# TECHNICAL BULLETIN

UPS4812-5bNAS1

### Update Prior to Sale: Front Subframe Bolts Incorrectly Torqued

XF (X250)

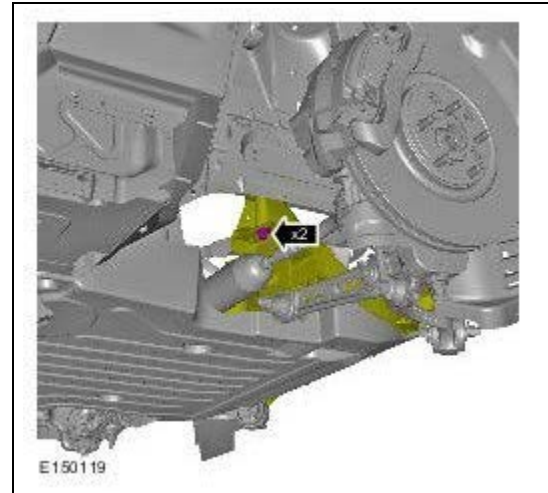
1. Refer to Workshop Manual section 100-02 and raise and support the vehicle.
2.  **NOTE: 5.0L Supercharged only.**  
Refer to Workshop Manual section 501-02 and remove the radiator splash shield.
3.  **NOTE: Remove and replace only one bolt at a time.**  
 **NOTE: Right-hand shown; left-hand similar.**  
Remove and discard the front subframe right-rear bolt.

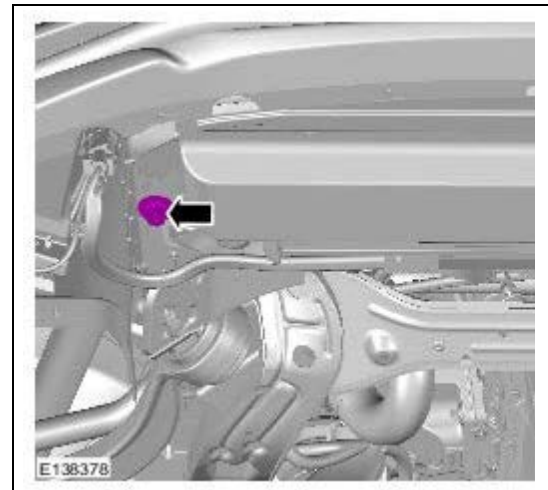
4. Install a new front subframe right-rear bolt.
  - Tighten the new bolt to 80Nm + 240° (59 lbf ft + 240°).
5. Remove and discard the front subframe left-rear bolt.
6. Install a new front subframe left-rear bolt.
  - Tighten the new bolt to 80Nm + 240° (59 lbf ft + 240°).
7.  **NOTE: Do not loosen / remove the bolt.**  
With a torque wrench set to 250Nm (185 lbf ft), over-check the torque of the front subframe right-front bolt.

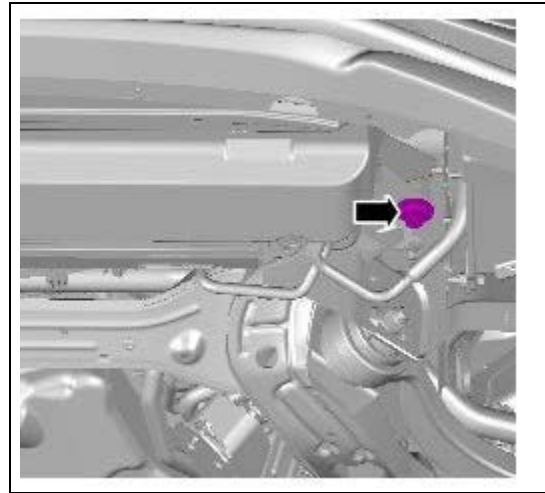
8.  **NOTE: Do not loosen / remove the bolt.**
- With a torque wrench set to 250Nm (185 lbf ft), over-check the torque of the front subframe left-front bolt.
